Subject: Amended MHI's Responses to US-APWR DCD RAI No. 379-2756 Rev 0

Amended Response to Request for Additional Information
No. 379-2756 Revision 0

**US-APWR Design Certification
Mitsubishi Heavy Industries, Ltd.
Docket No. 52-021**

RAI NO.: NO. 379-2756 REVISION 0
SRP SECTION: 06.01.01 – ENGINEERED SAFETY FEATURES MATERIALS
APPLICATION SECTION: 6.1.1
DATE OF RAI ISSUE: 5/29/2009

Figure 1 SCC resistance of stainless steel against dissolved oxygen

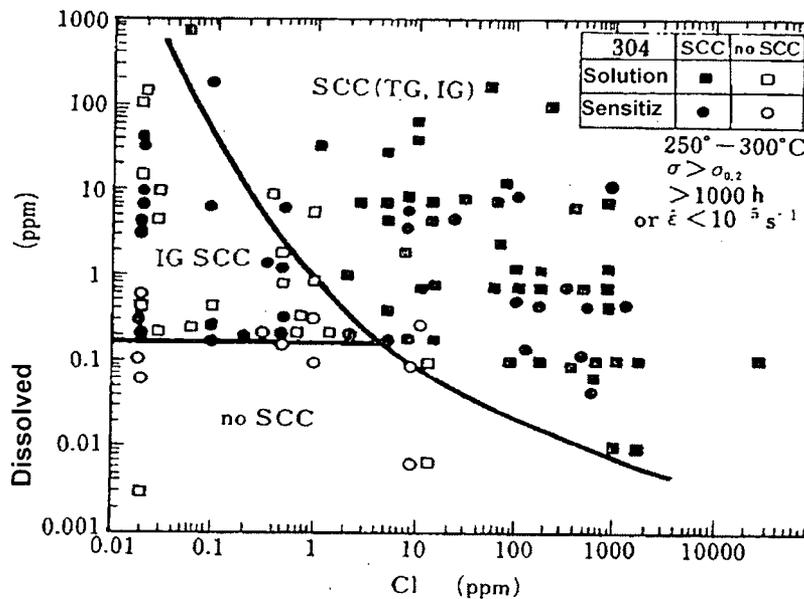
Table 6.1-1 indicates that non-low carbon austenitic stainless steels will be used to fabricate some ESF components. Given that the use of stainless steels, in LWRs, with a maximum carbon content of 0.03% has been shown to be highly resistant to stress corrosion cracking, the staff requests that the applicant modify FSAR Section 6.1.1 and Table 6.1-1 to limit the carbon content of austenitic stainless steel to 0.03% maximum or provide a technical basis for why this is not necessary.

Figure 1 shows the SCC potential of stainless steel as a function of dissolved oxygen and chlorides (Reference: 1st U.S. - Japan Joint Symposium on Light Water Reactors, Fuji, Japan (1978), presented by M. O. Speidel). This figure shows that SCC does not occur in the zone where dissolved oxygen and chlorides are low, even if the SS is sensitized. The US-APWR reactor coolant chemistry is well within the no-SCC area below the curve. This means that the standard grades of SS will not experience IGSCC in the US-APWR environment.
